STATE OF VERMONT  
 AGENCY OF TRANSPORTATION  
 TOWN OF BOLTON  
 PROJECT NO.: IM-089-2 (29)  
 BRIDGE NO.'S 51N AND 51S  
 ON INTERSTATE 89

COSMEC, INC. 70 SOUTH STREET  
 WALPOLE, MA. 02081  
 SCALE: 1/4"=1" DRAWN BY: JEP CHECKED BY: PJM  
 SHT 1 OF 12 DATE: 01/05 DATE: 02/05  
 COSMEC BEARING bb315  
 CUSTOMER: WINTERSET S.O. NUMBER: 60233 DRAWING NUMBER: 4360 REV: 1

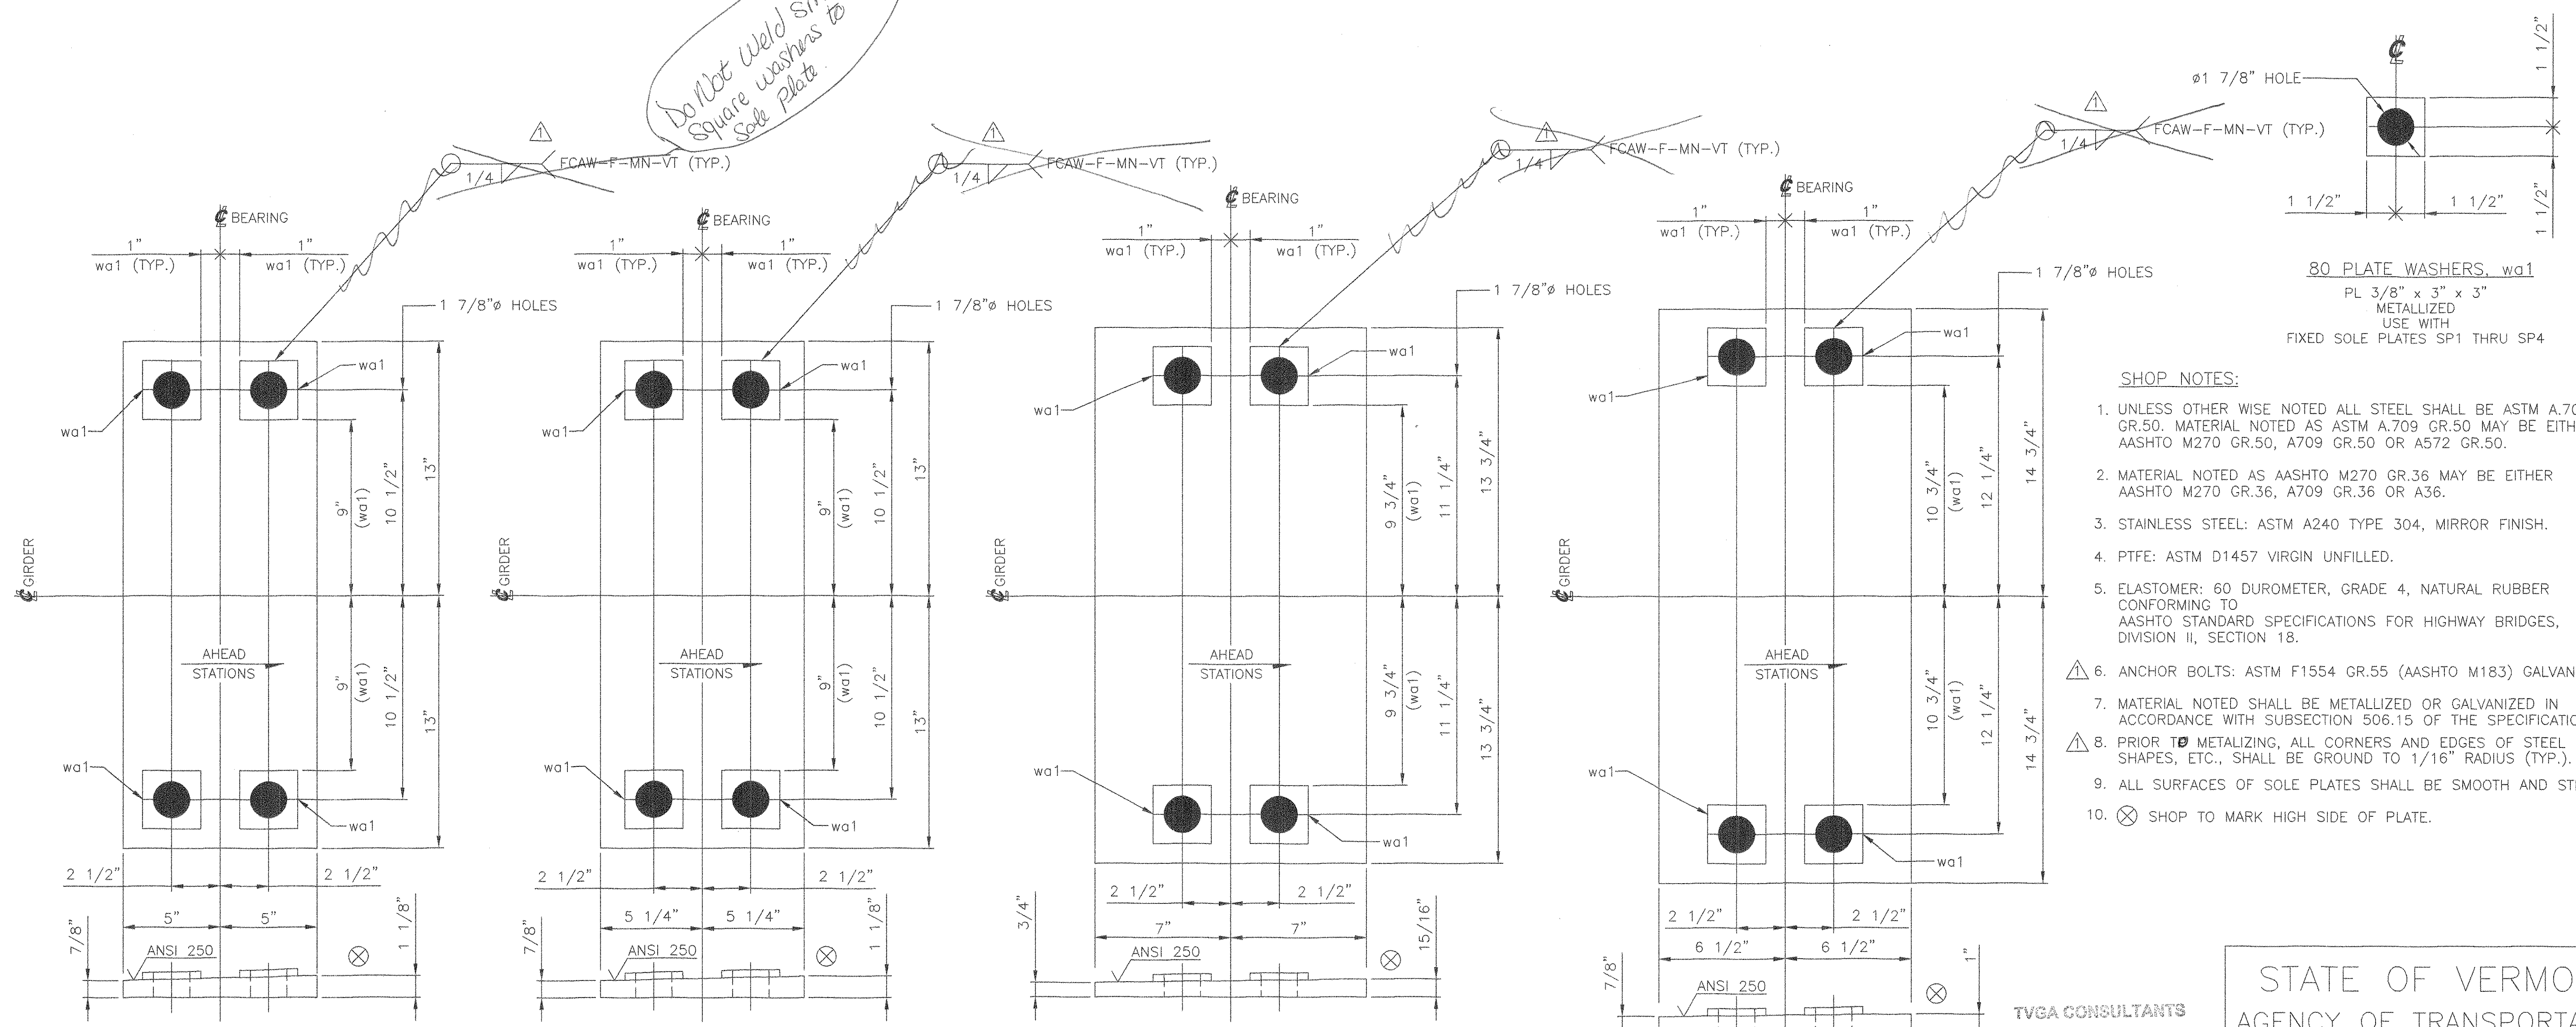
Do Not Weld Small Square Washers to Sole Plate

REV.	REVISOR	DATE	CHK'D BY	DATE
1	REVISED NOTES 6 & 8 REVISED WELDS ON WASHERS AND REVISED METALIZING ON SOLE PLATES	4/05	MM

NO EXCEPTIONS TAKEN  
 FURNISH AS CORRECTED  
 REVISE AND RESUBMIT  
 ENGINEER has reviewed Shop Drawings and Samples and other data which Contractor is required to submit, for compliance with the information given in the Contract Documents and compliance with the work covered by the complete project or a particular whole as indicated in the Contract Documents. Such review is not intended to insure, methods, techniques, accuracy or procedures of construction or to imply preparation and programs inherent thereto. Contractor is responsible for dimensions to be confirmed and completed at the job site; for information that pertains solely to the fabrication processes or to techniques of construction, and for coordination of the work of all trades.
